SURFACE TRANSPORTATION BOARD
Section of Environmental Analysis
Draft Environmental Impact Statement for the
ALASKA RAILROAD CORPORATION'S
PROPOSED NORTHERN RAIL EXTENSION

COMMENT FORM

The following points are my concerns with the Draft Environmental Impact Statement. My concerns are near a populated settlement called the "Richardson Clearwater" and is near the "South Common Segment" between "Donnelly 1 and Delta 2"

Figure S-6 - South Common Segment and Alternative Segments within Map Area 5

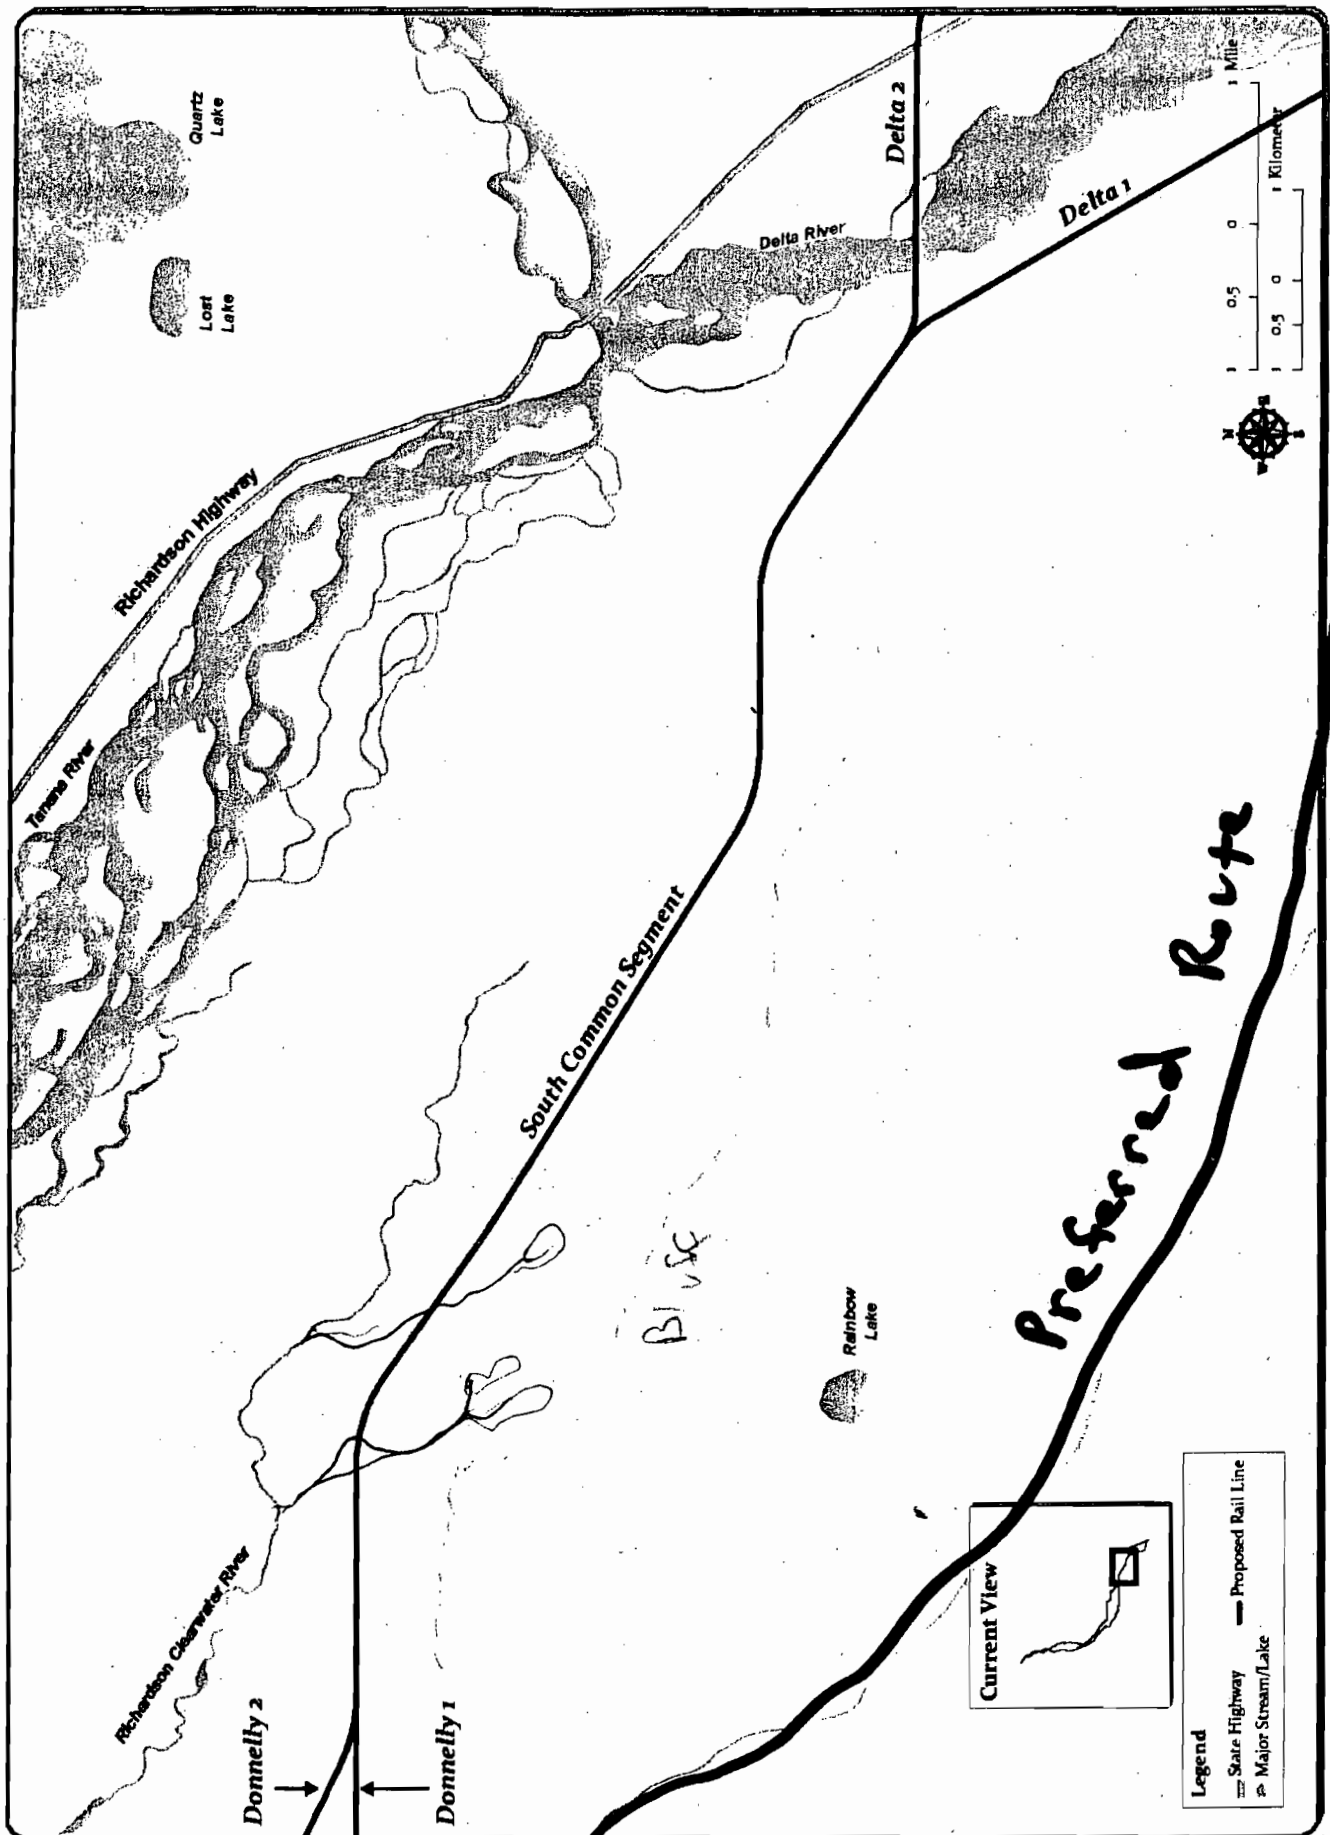
2. The route crosses the "Richardson Clearwater in at least two locations or more at the head waters of two tributaries. This is a major concern for the Grayling, White fish and Salmon spawning species of fish. What study has been done about the impact of the fish population during and after construction?

6. The South Common Segment route is not acceptable and should be moved further to the south close to the Military Training Boundary Line and South of Rainbow Lake. This would satisfy most of my concerns.

16. STB is required in the Transportation Act to be a "good neighbor" and the property owners of the Richardson Clearwater expect nothing less. Our wish is to relocate the route to the south connecting Donnelly 1 following a new route along the military boundary south of Rainbow Lake and connecting to Delta 1 and/or Delta. Can this be done?
